# **EiC CaloReview**

***Close-Out***

***December 6 – 8, 2022***

# Backward ECal - EEMCAL

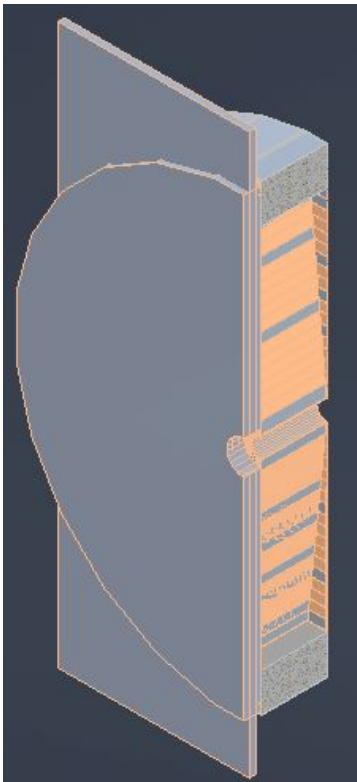
- Findings
  - Project centrally crucial for success of EIC Physics program: detection of scattered electron
  - PWO is an established technology and is the best choice for this sub-detector

- Position resolution missing
  - Readout with matrix of SiPM
  - Material in front of EEMCAL unclear
  - e/pi still a factor 10 to improve although not critical

- Comments/Concerns
  - Temperature stability is very crucial for long-term operation and has to be verified
  - Avoid heating of crystals due to front-end electronics

- No thermal insulation ( $0.5^{\circ}\text{C} \leftrightarrow 1.2\%$  light yield adding to rest of constant term)
  - Front-end electronics to be decided

- Avoid fixations with nuts in forward part, use fixed conical bolts
  - The availability of PWO can be a major risk (single supplier of high-quality material!)

- Recommendations
  - Prepare a system test with close-to-final electronics
  - Assess impact on physics output due to temperature instabilities
  - Procure PWO crystals as soon as possible as it is a long lead item ( $\sim 700$  crystals/year)

# Backward HCal – Tail Catcher

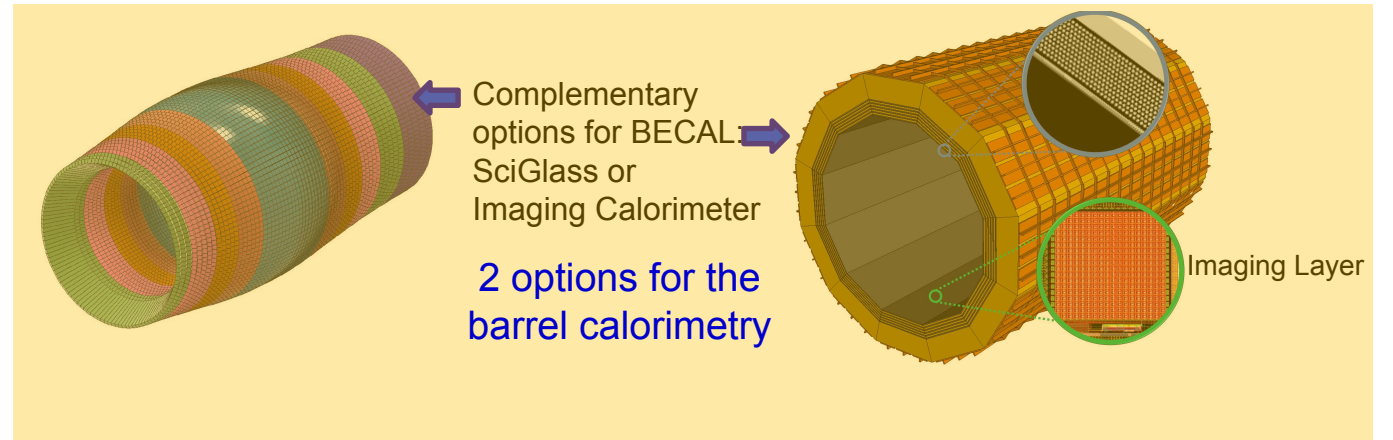
- Findings
  - Locations of SiPM not yet clear
- Comments/Concerns
  - Make the detector easily removable to access Backward EMCal readout
- Recommendations
  -

# Barrel ECal – Pb/SciFi+Imaging

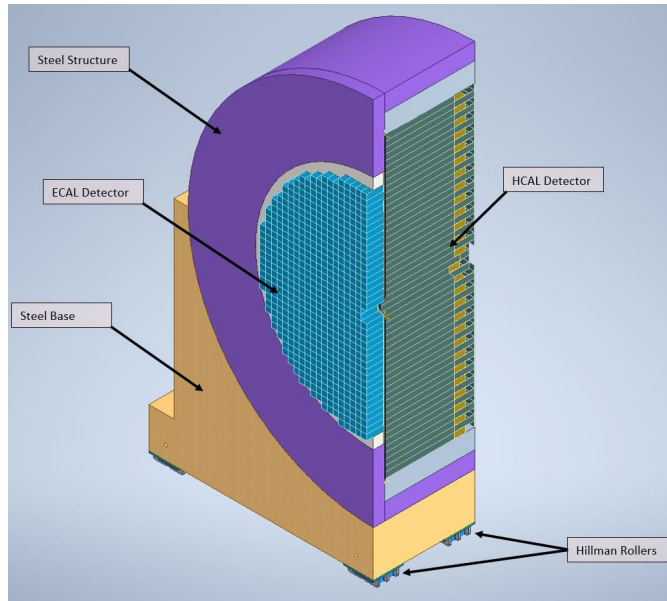
- Findings
  - Application of AstroPix MAPS ASIC in imaging part
  - Long fibres and lead sheets in main part
  - No full simulation, no prototypes or more detailed engineering test articles yet
  - Potential to leave out MPGD part
- Comments/Concerns
  - Integration and cooling
  - Installation and maintenance of self-supporting barrel is difficult
  - Consider having only Pb/SciFi as backup, simulate resolution
- Recommendations
  - Do full physics simulation as soon as possible
  - Move towards tests of prototypes or more detailed engineering test articles as soon as possible

# Forward EMCaI

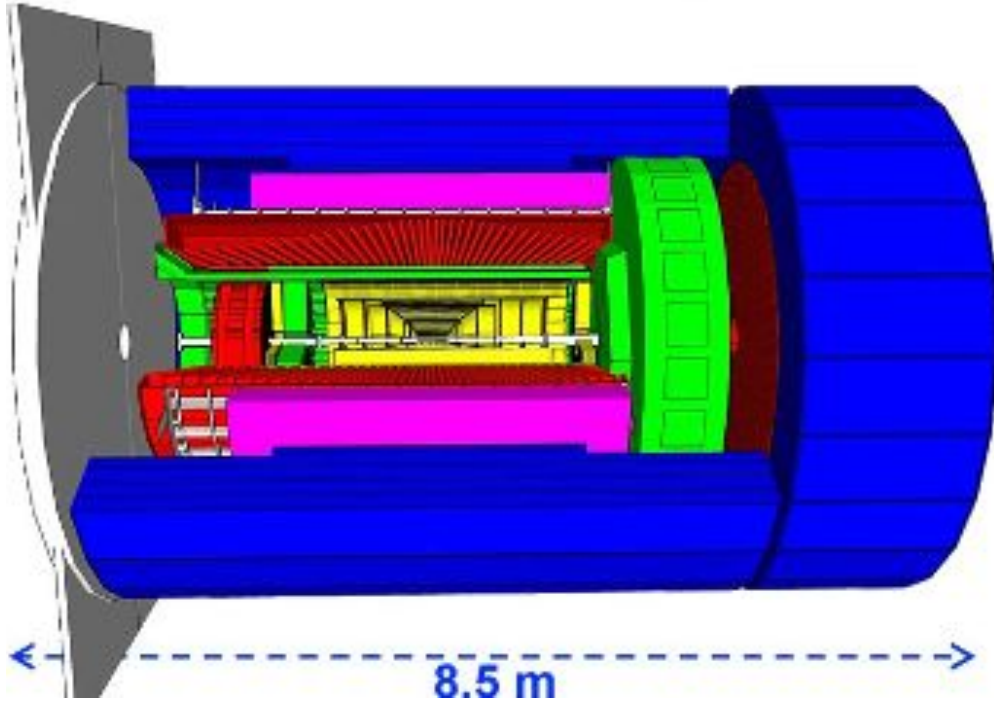
- Findings
  - W/SciFi to reach 10%/√E and  $e/h \sim 1$
  - Experience from sPHENIX
  - Well trained team
- Comments/Concerns
  - Inhomogeneity as function of fibre arrangement to be validated in test
  - Readout on front side: light guides, sensors, electronics, cables, cooling
    - => Electronics exposed to proton/heavy ion remnant
    - => Worsening of elm. resolution
- Recommendations
  - Full simulation with passive structures in front to study effect on resolution
  - beam test of engineered structure including realistic upstream electronics

# Detector Integration

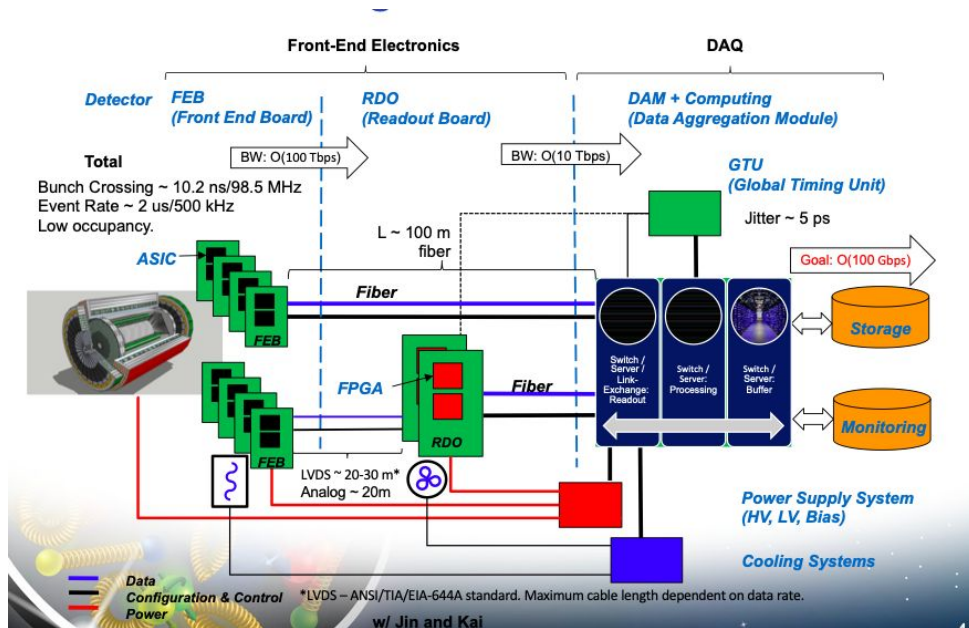
- Findings
  - For many systems placeholder volumes are used
  - Measurements of electrons and electromagnetic shower is crucial for scientific output
- Comments/Concerns
  - Structured design of supports and services to be entered also in simulation
  - Do load checks and eventually FEM of static and dynamic cases (seismic events, moving detector)
  - Early stage of cabling and detector design
- Recommendations
  - Define tolerances and keep-out volumes to facilitate integration of systems
  - Follow design steps and hardware development with full simulation studies to identify critical aspects of detector design for precision physics
